**VALUE ENGINEERING CHANGE PROPOSAL  
MISSOURI DEPARTMENT OF TRANSPORTATION**

Contract ID 080919-401      Job No. J4I1650

County Jackson      I - 470      Original Bid Cost 14,338,653.90

VECP# 10-38 (to be completed by C.O.)      VECP  or PDVECP

ALTERNATE GRADING TYPICAL SECTION  
 Right Side Sta. 43+00 to Sta. 46+50  
 Left Side Sta. 44+00 to Sta. 46+50  
 Not To Scale

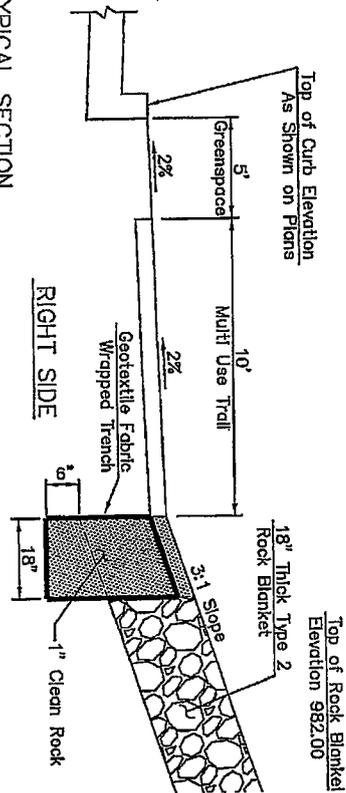
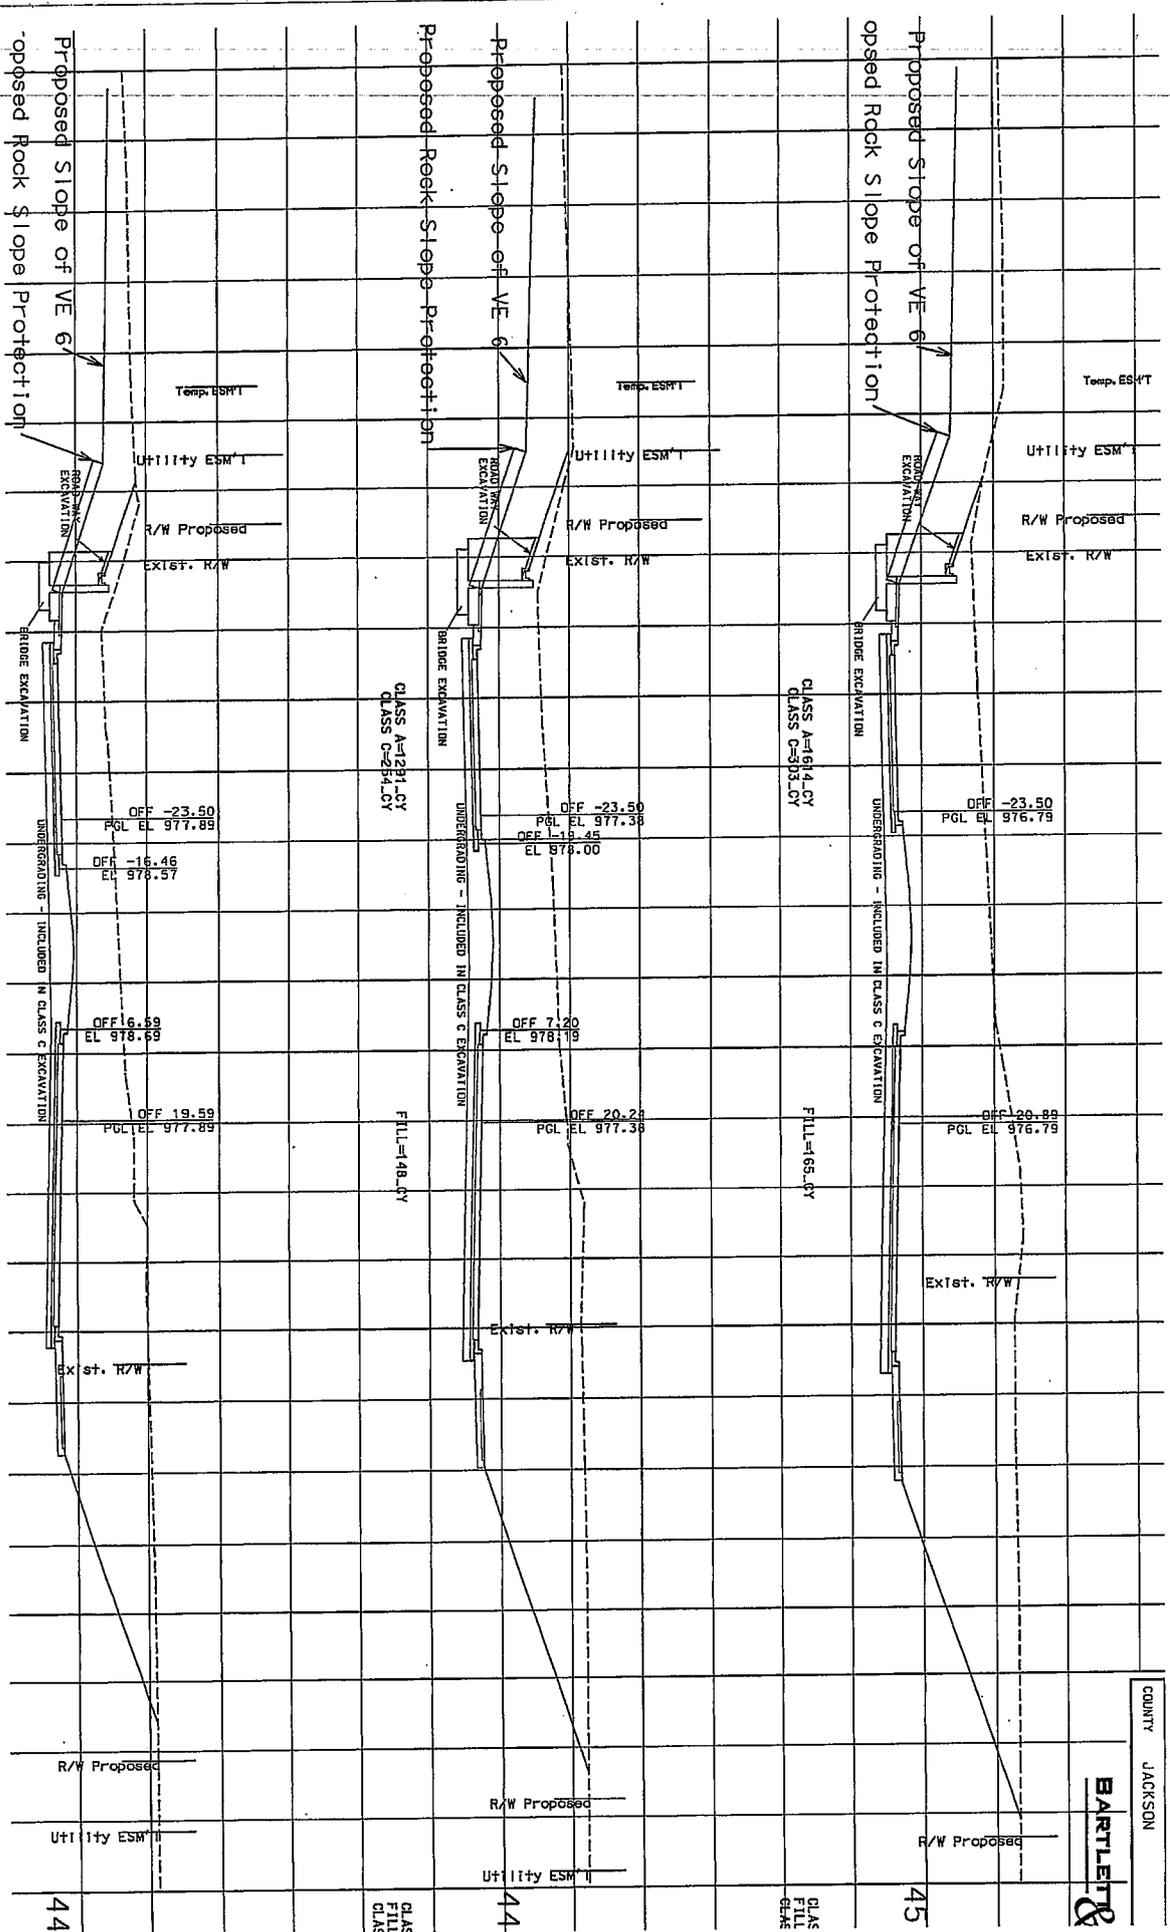
**1. Description of existing requirements and proposed change(s). Advantages/Disadvantages**  
 The current design of Strother consists of Bridge Item A7505, Porous Backfill, underdrain and Type B Gutter. Proposed change will eliminate these items at Sta. 44+00.00 to 46+33.47 LT. Proposed changes include Type 2 Rock blanket at 3:1, French Drain, lowering elevation of adjacent property left of Sta. 44+00.00 to 46+33.00 to 984.00. The main advantage of this proposal, besides cost savings, is the elimination of safety hazards created by existing KCPL power pole located 67.18 ft. left of Sta. 46+65. See additional comments.

The attached "sketch" is the typical section through the sidewalk and back slope along Strother Road. Now I understand Kevin Irving's concern about the 1" gravel rolling onto the sidewalk.

5. The proposed 1" clean rock has the likelihood of spilling over onto the sidewalk and therefore will be a maintenance issue and a nuisance to pedestrians and bicyclists.

We will accept a VE containing this redesign of the sidewalk section.
